Addendum #2

Bid Opportunity: 23-7362-RFT

**Waterloo-Oxford District Secondary School –
Family Studies Renovation & HVAC Upgrades**

A3.2R

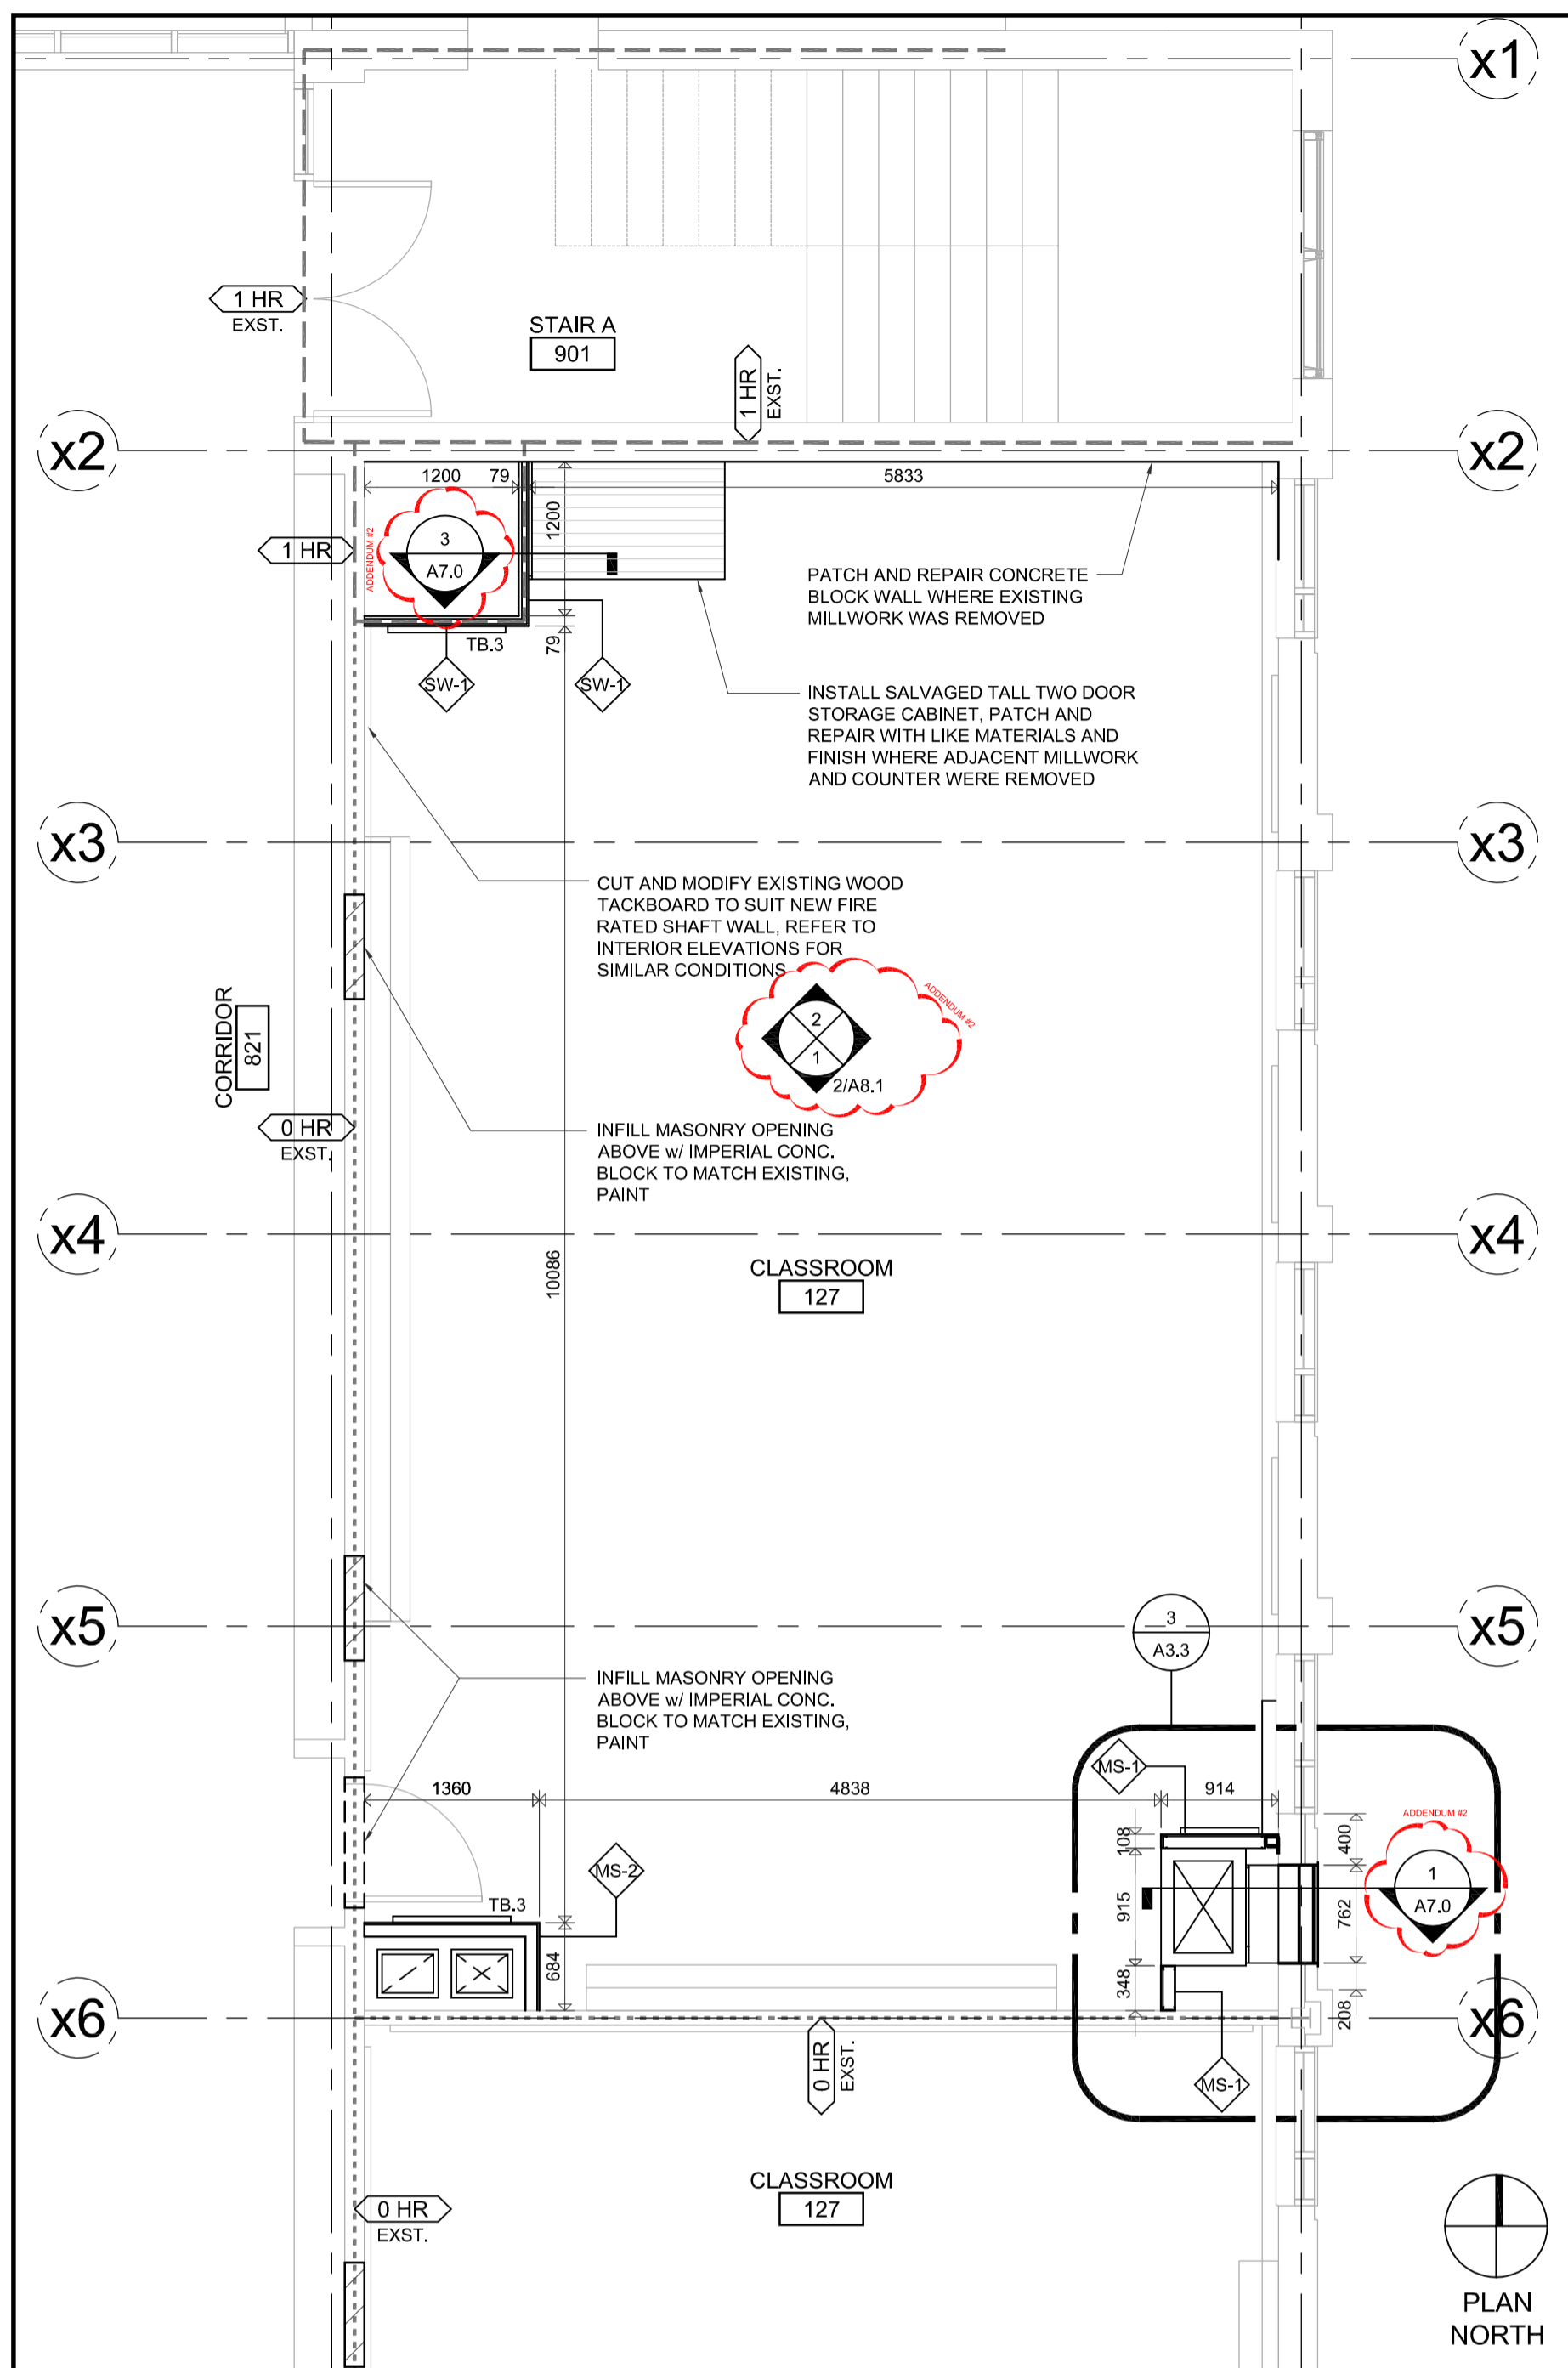
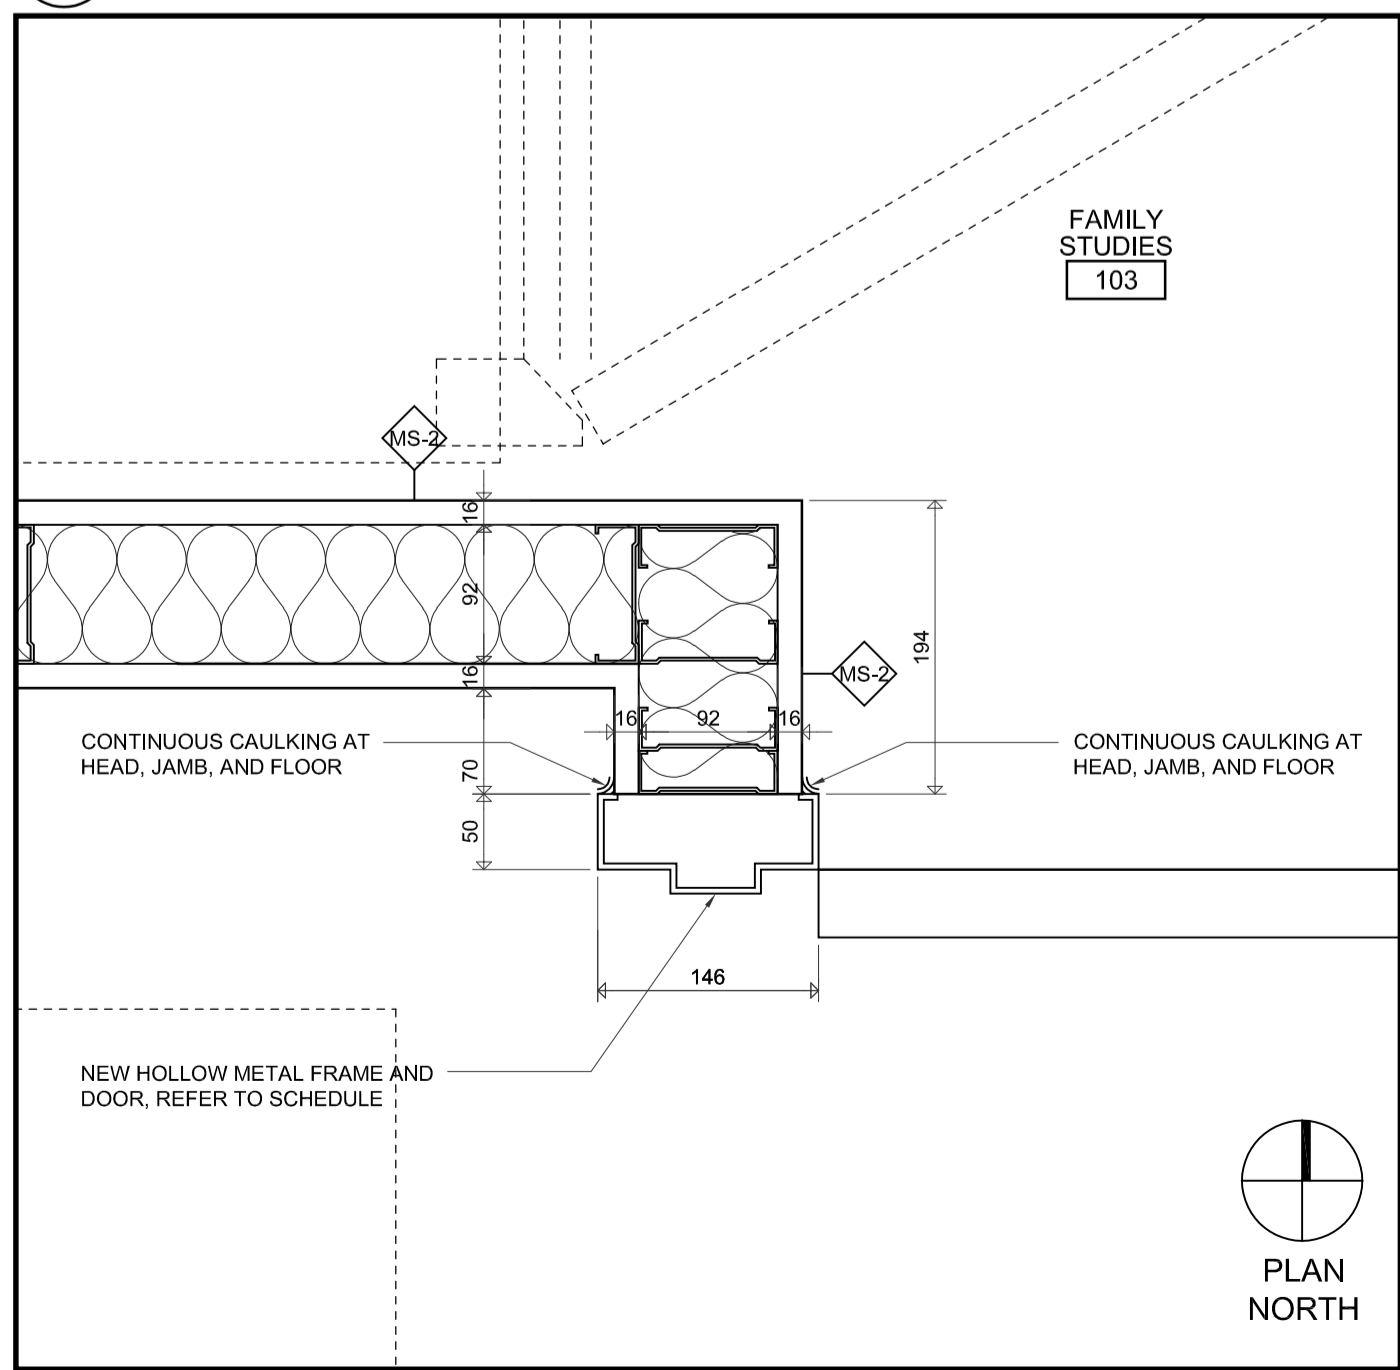
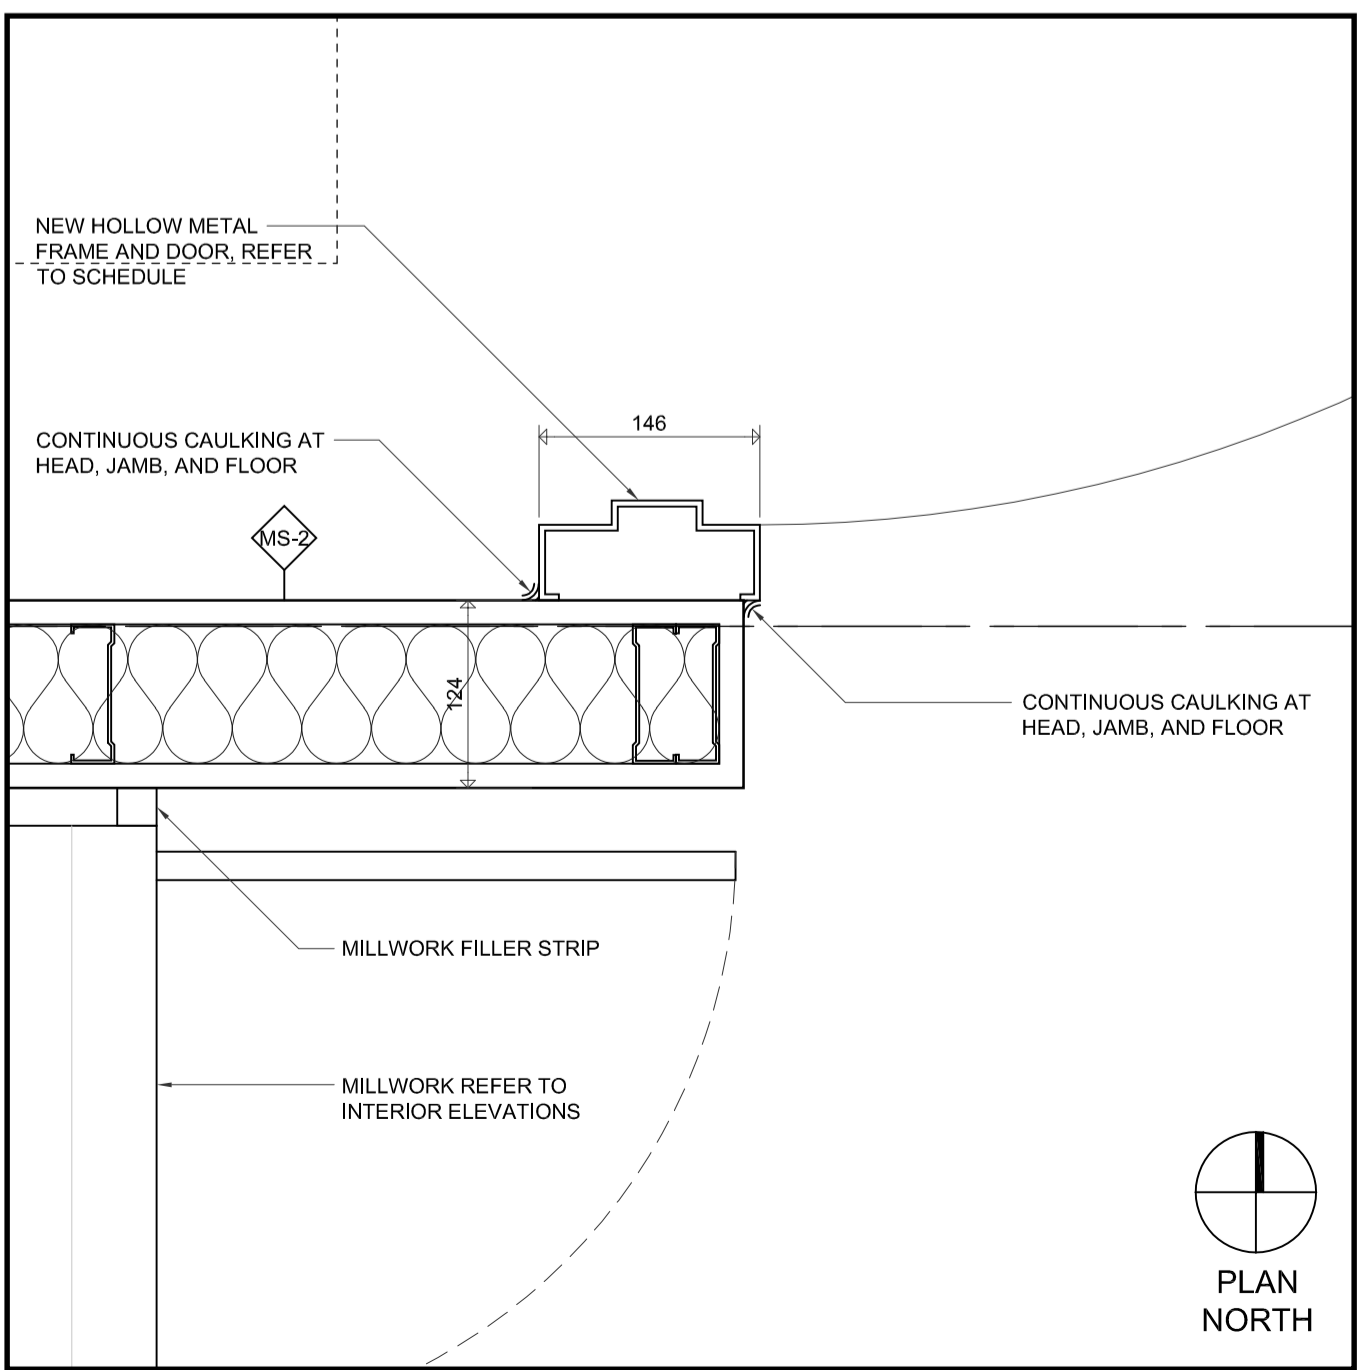
7. Drawing A3.2 Enlarged Floor Plans & Plan Details
 1. **REPLACE DRAWING A3.2 WITH DRAWING A3.2R, ATTACHED. DETAIL REFERENCES HAVE BEEN ADDED/ REVISED.**

2 WALL SECTION
A7.0
ADDENDUM #2

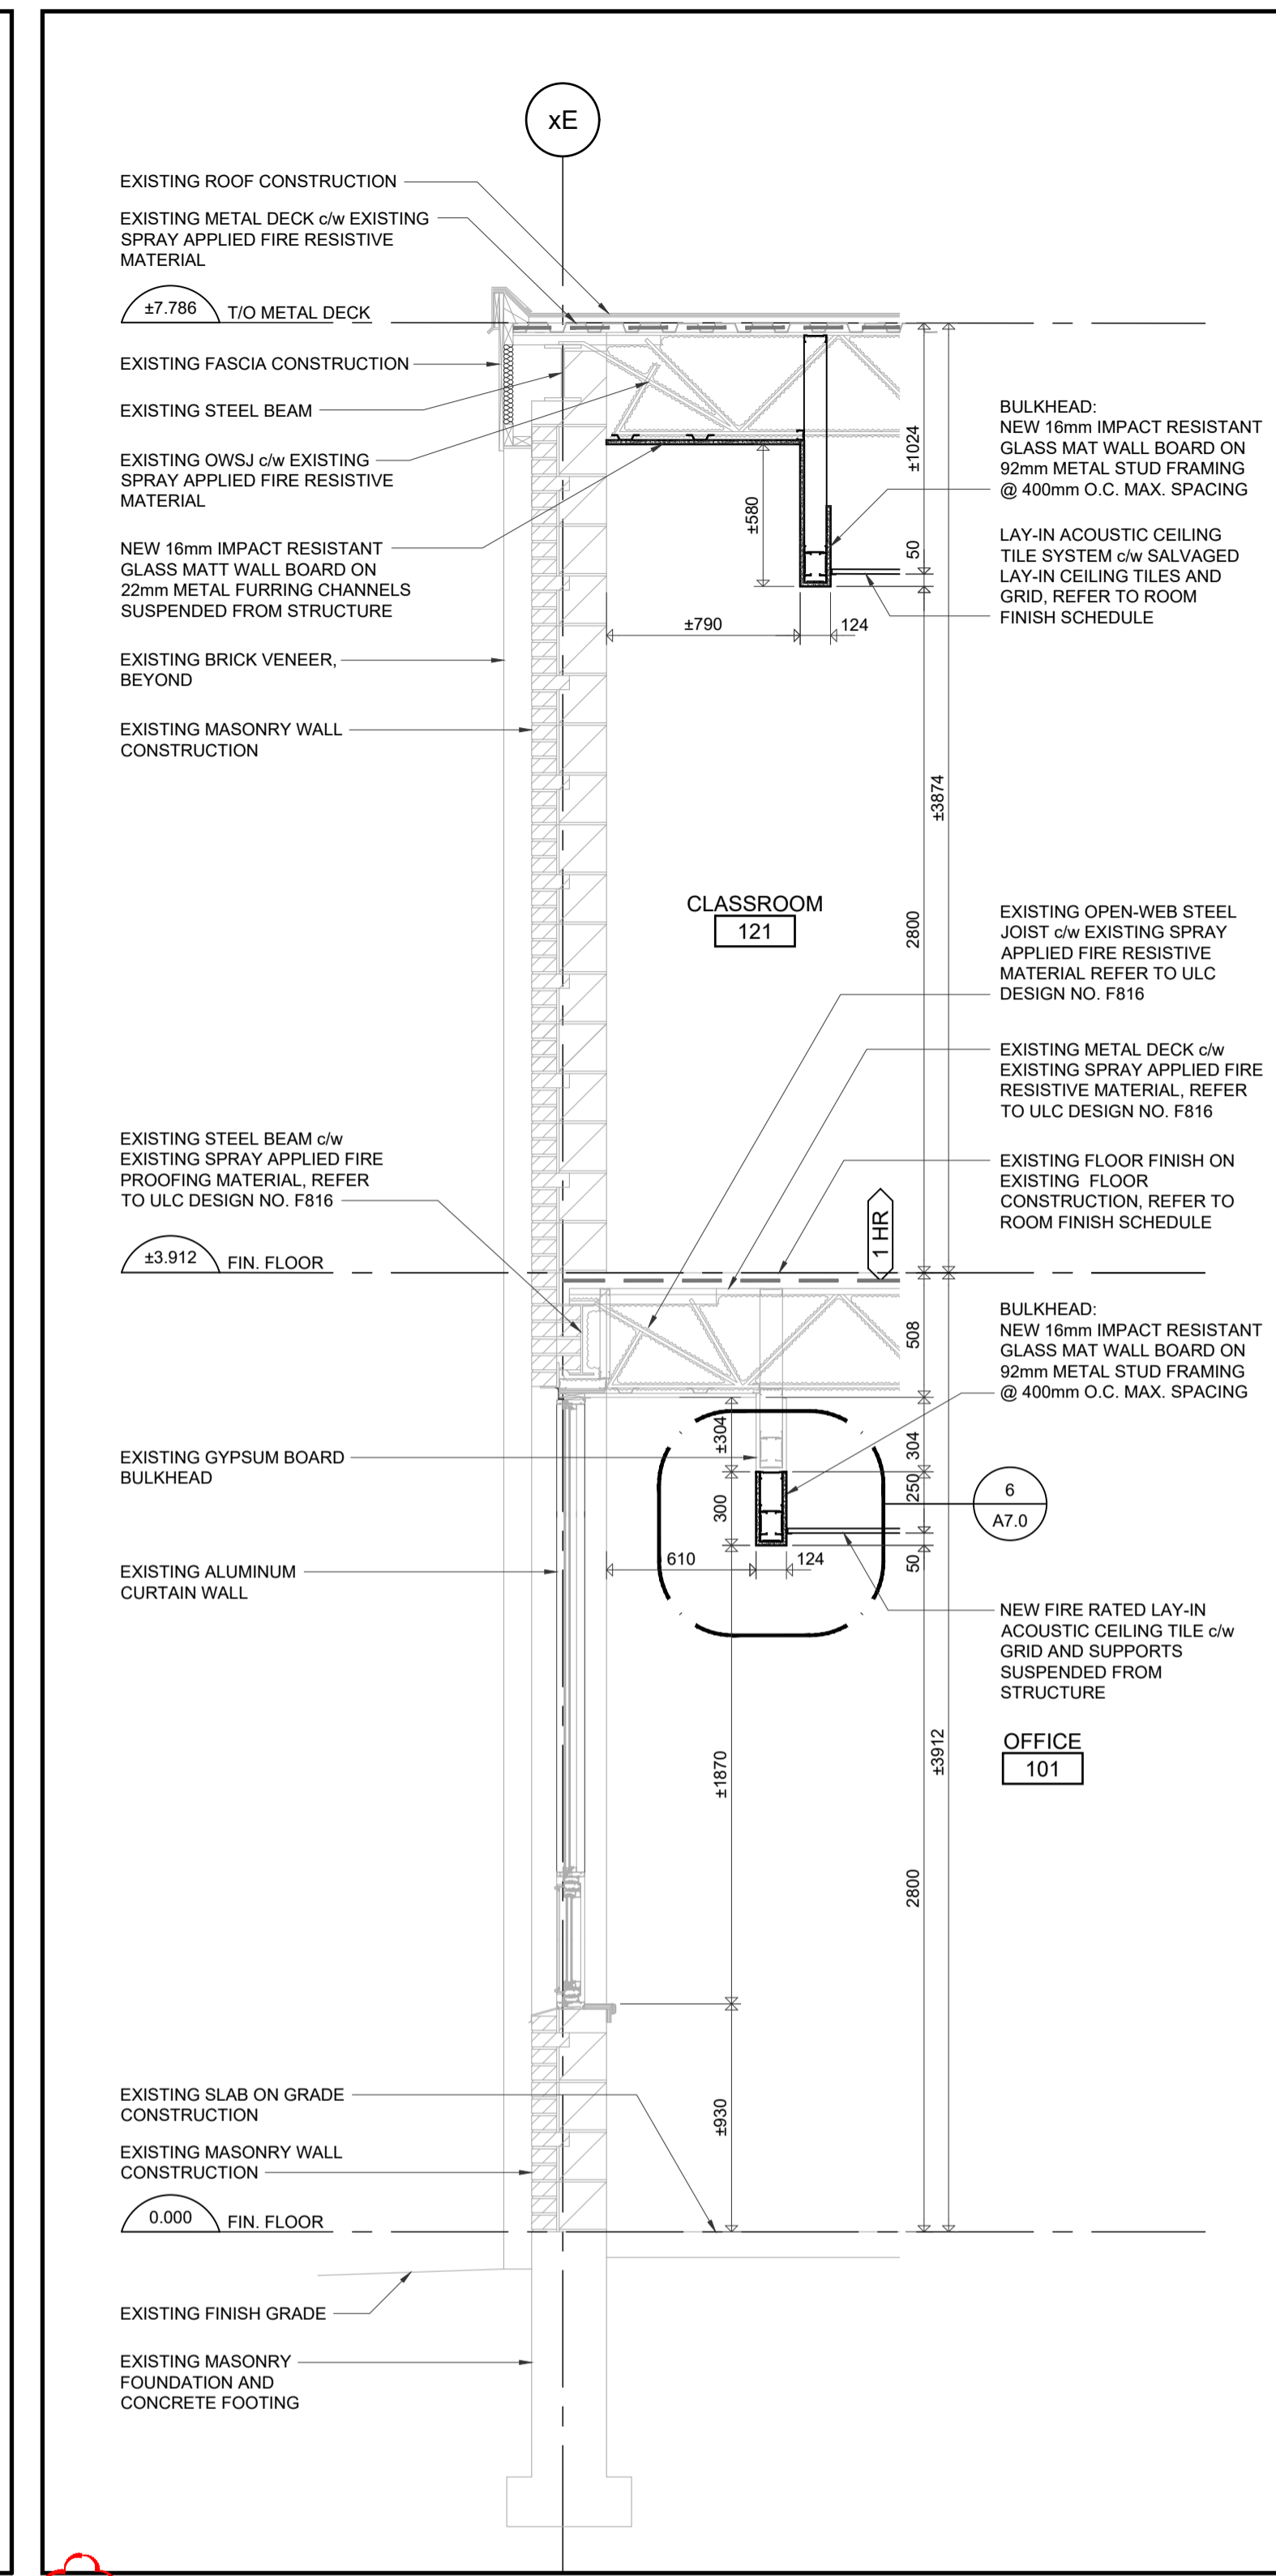
Drawing A7.0 shows 2 details labelled 1/A7.0; which one is correct? And is there supposed to be a 1/A7.0 which is not on the drawings?

As per drawing A3.1, Section of wall adjacent to Grid X16 - xD is shown on drawing A6.1 section 1 but there is no such drawing. There is a section shown on Drawing A7.0 section 1, please confirm if the detail shown on drawing A7.0 is of the same location, if not please can you issue drawing A6.1

8. Drawing A7.0 Wall Sections and Section Details
 1. **REPLACE DRAWING A7.0 WITH DRAWING A7.0R, ATTACHED. DETAIL REFERENCE HAS BEEN REVISED.**
